Appendix I of RNTPC
Paper No. A/YL-LFS/512A

APPLICATION FOR PERMISSION
UNDER SECTION 16 OF
THE TOWN PLANNING ORDINANCE
(CAP. 131) YL-LFS

(a) Proposed use(s)/development 擬議用途/發展	擬議臨時公眾停車場 (中型貨車) Proposed Temporary Public Vehicle Park for Medium Goods Vehicles (Please illustrate the details of the proposal on a layout plan) (請用平面圖說明擬議詳情)

Planning Application No. A/YL-LFS/512

Proposed Fire Services Installation

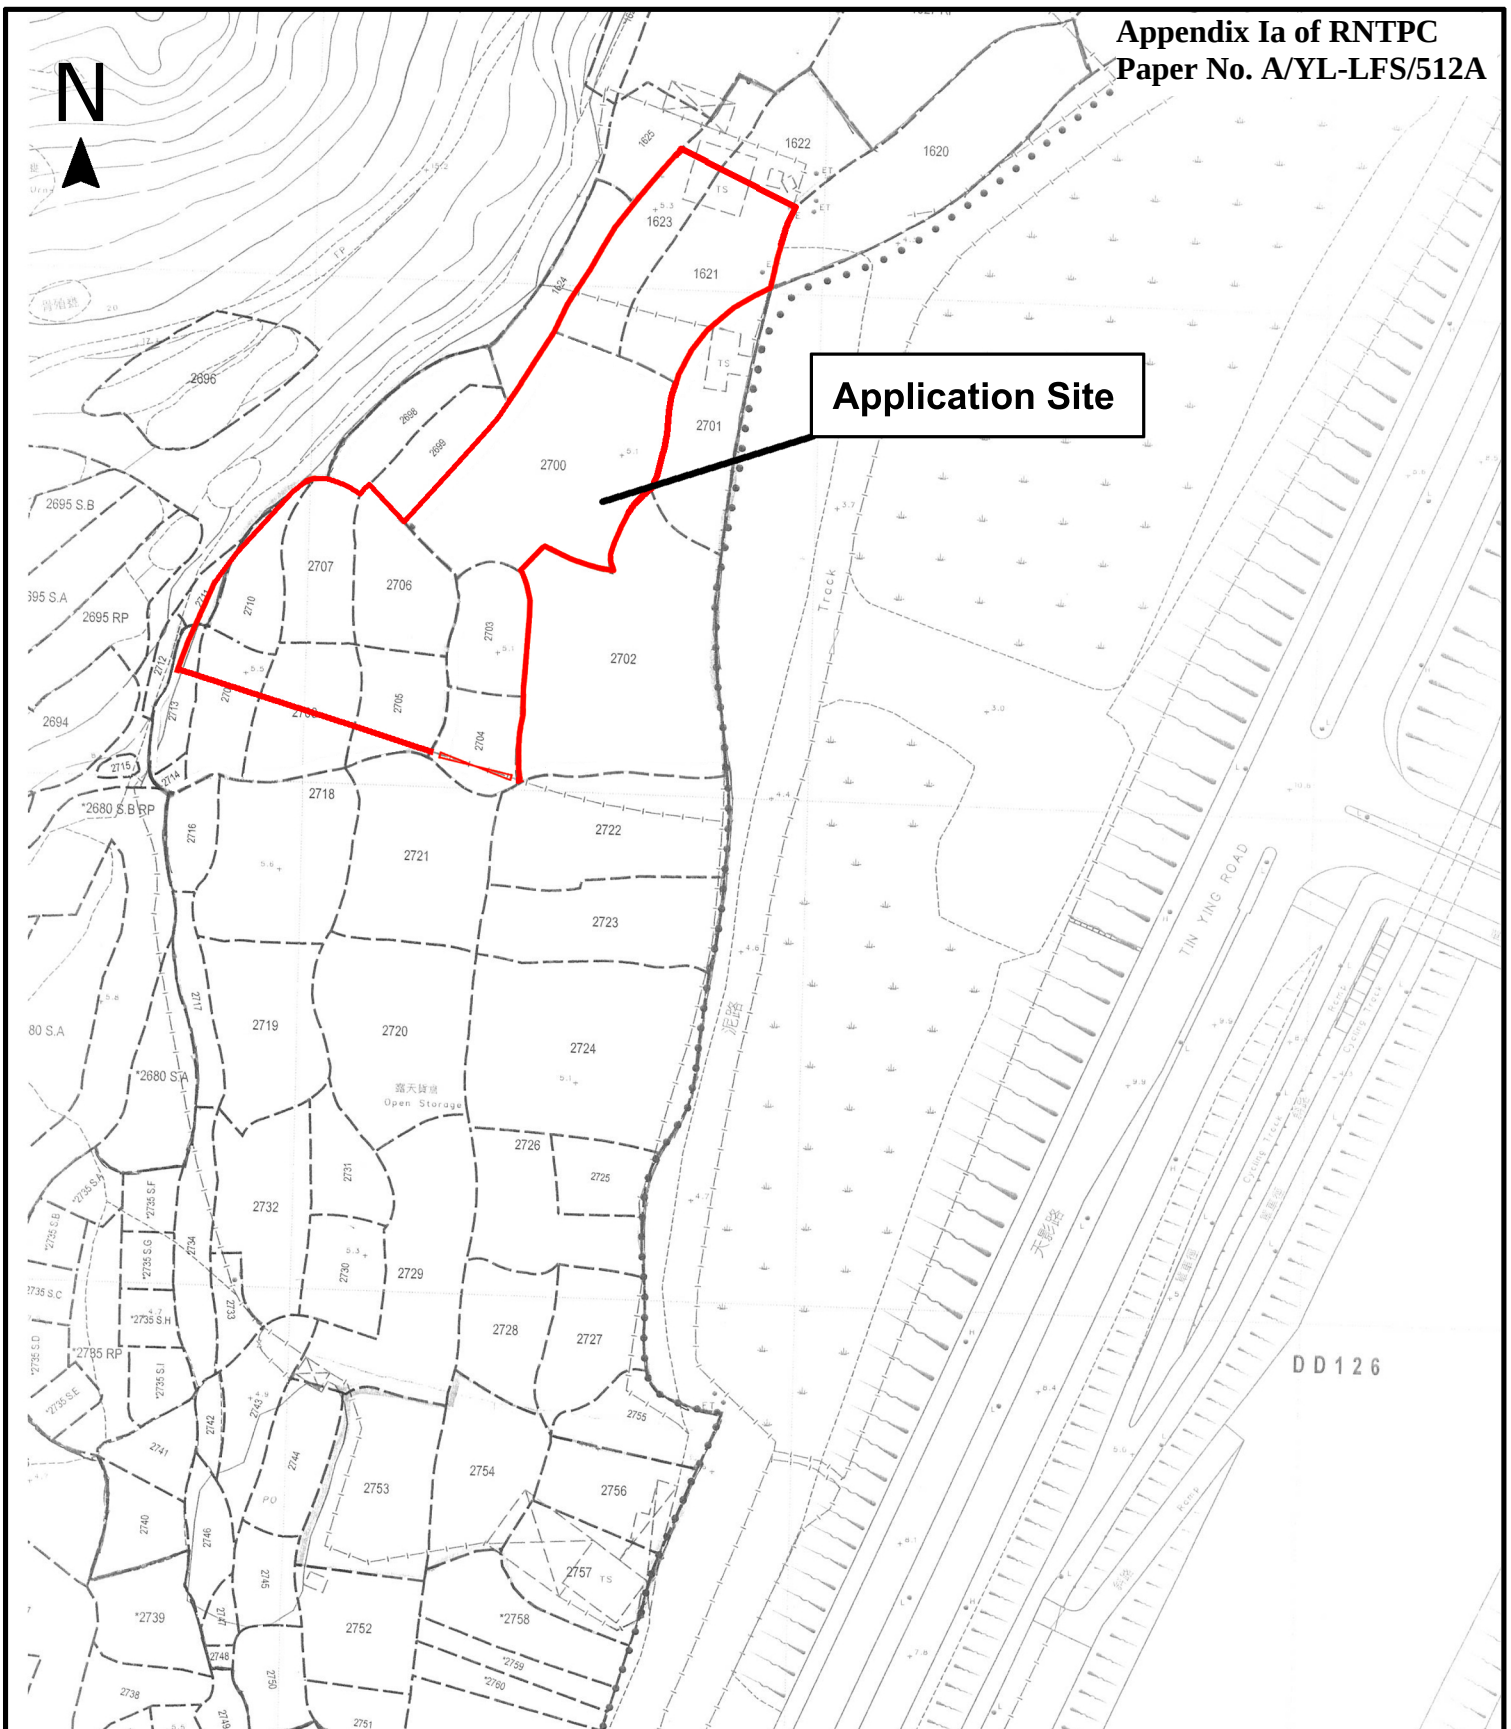
Departmental Comments	Responses
	Director of Fire Services	
(a)	Regarding the submitted fire service installations proposal, the proposed emergency lighting and directional and exit sign as mentioned in the FS Notes shall be clearly marked on plan.	申請用途是停車場，按照消防指引，申請地點不用擺放緊急照明燈及逃生指示牌，申請人之前遞交的消防圖則有誤，現已重新遞交更改過的消防圖則，請看附件 1。

Appendix C - Proposed Drainage Plan

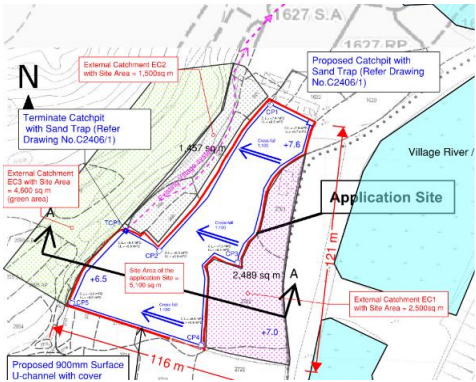
No.	Comments	Response
1.	Peripheral surface channels shall be provided along the site boundary to collect the surface runoff accrued on the application site and to intercept the overland flow from the adjacent land.	Noted. Please refer to the revised Appendix C – Drainage Plan.

4.	The up-hill ground to the west of the application site is generally higher. Since the overland flow from the adjacent lands shall be properly intercepted, external catchment to the west of the site (other than EC1 and EC2) shall be considered in the calculation	Noted. The up-hill ground to the west of the application site was included as external catchment EC3 in the calculation. Please refer to the revised Appendix D - Drainage Calculation.

5.	Sand trap or provision alike should be provided at the immediate discharge point outside the application site boundary before the before conveying to any drainage system fall outside the application site.	Terminate Catchpit with Sand Trap is provided at the discharge point of the application site. Noted. Please refer to the revised Appendix C – Drainage Plan.

6.	Cross sections showing the existing and proposed ground levels of the captioned site with respect to the adjacent areas should be given.	Noted and provided. Please refer to the revised Appendix C – Drainage Plan.

No.	Comments	Response
1.	The cover levels and inverted levels of the proposed u -channels, catchpits/sand traps should be shown on the drainage plan.	Noted and provided. Please refer to the revised Appendix C – Drainage layout.
2.	Standard details should be provide to indicate the sectional details of the proposed u-channel and the catchpits/sand traps.	The standard details are provide in Appendix E - Typical Standard Drawings of U-Channel and Catchpit.
